Second Preliminary Consultation
MONTGOMERY COUNTY HISTORIC PRESERVATION COMMISSION
STAFF REPORT

Address:	4721 Essex Ave., Chevy Chase	Meeting Date:	1/25/2017
Resource:	Primary (Pre-1915) Resource (Somerset Historic District)	Report Date:	1/18/2017
Applicant:	Richard and Michelle Scurfield	Public Notice:	1/11/2017
		Tax Credit:	N/A
Review:	2 nd Preliminary Consultation	Staff:	Michael Kyne
Case Number:	N/A		
PROPOSAL:	Rear addition

HPC Preliminary Review Submission

Scurfield Addition

1 4721 Essex Avenue Site Plan
1/16" = 1'-0"

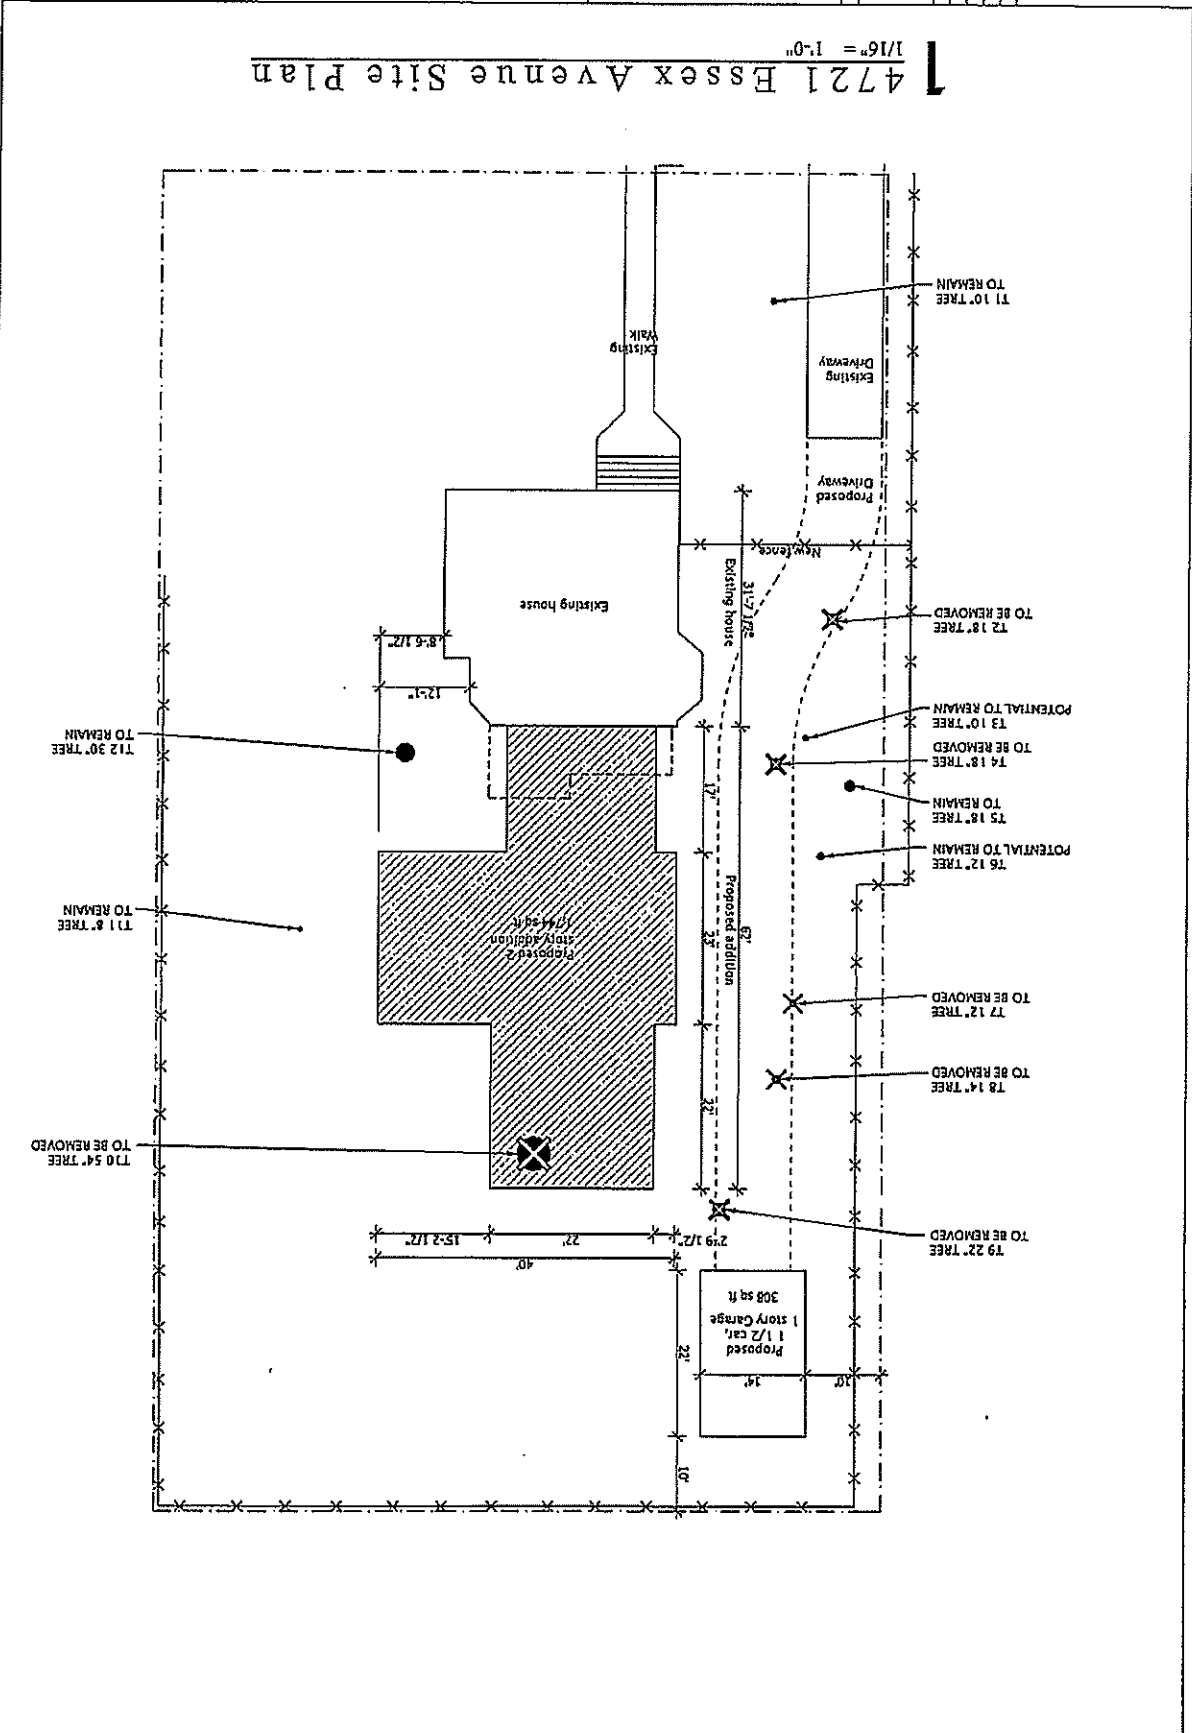
- **Shape/Orientation:** Staff urges the Commission to consider whether the overall shape and orientation of the proposed rear addition, as it relates to the historic house, is compatible. When viewing the site plan, the historic massing is roughly square shaped, while the proposed addition consists of a series of rectangles. Staff suggests that, with its the architectural features and orientation, the addition has the potential to detract from “the spacing and rhythm of buildings, the uniform scale of existing houses, the relationship of houses to the street, the ample size lots and patterns of open space in the neighborhood.”

At this time, a tree protection/replacement plan has not been provided, but the applicants have noted that they intend to reforest the left side of the property, where the trees will be removed to accommodate the proposed new driveway.

1 Existing Front Massing

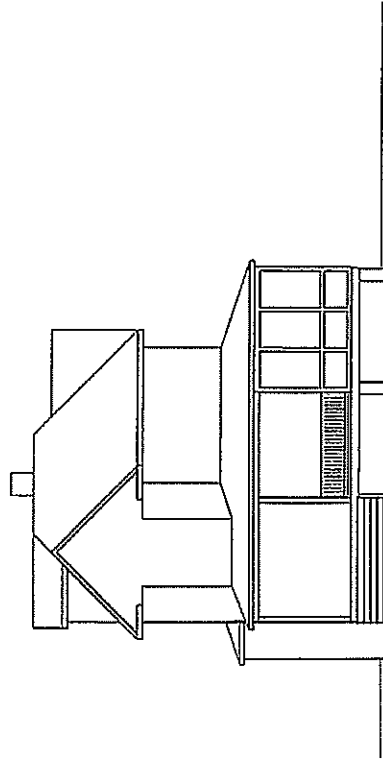
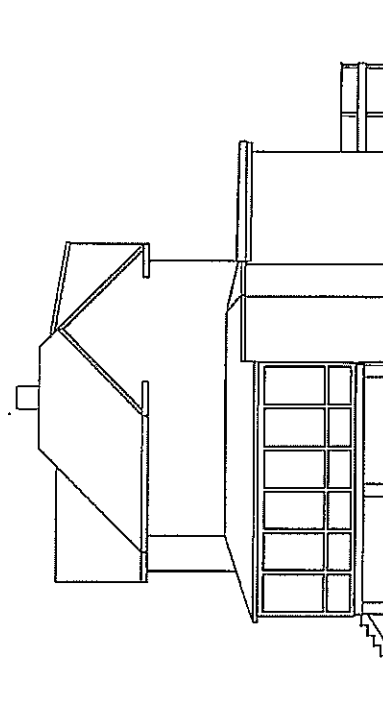
16 MS. BARNES: I have a couple of questions. One,
17 we're looking at the screened porch which protrudes a bit to
18 the side of the house, and it's unclear to me from the
19 drawings that we have, for example at Circle 49, where the
20 original house is shown, does that include the, I think it
21 was 49 I read -- 48, I beg your pardon -- does that include
22 the porch when you show existing house?

1 MS. DECKER: Correct.
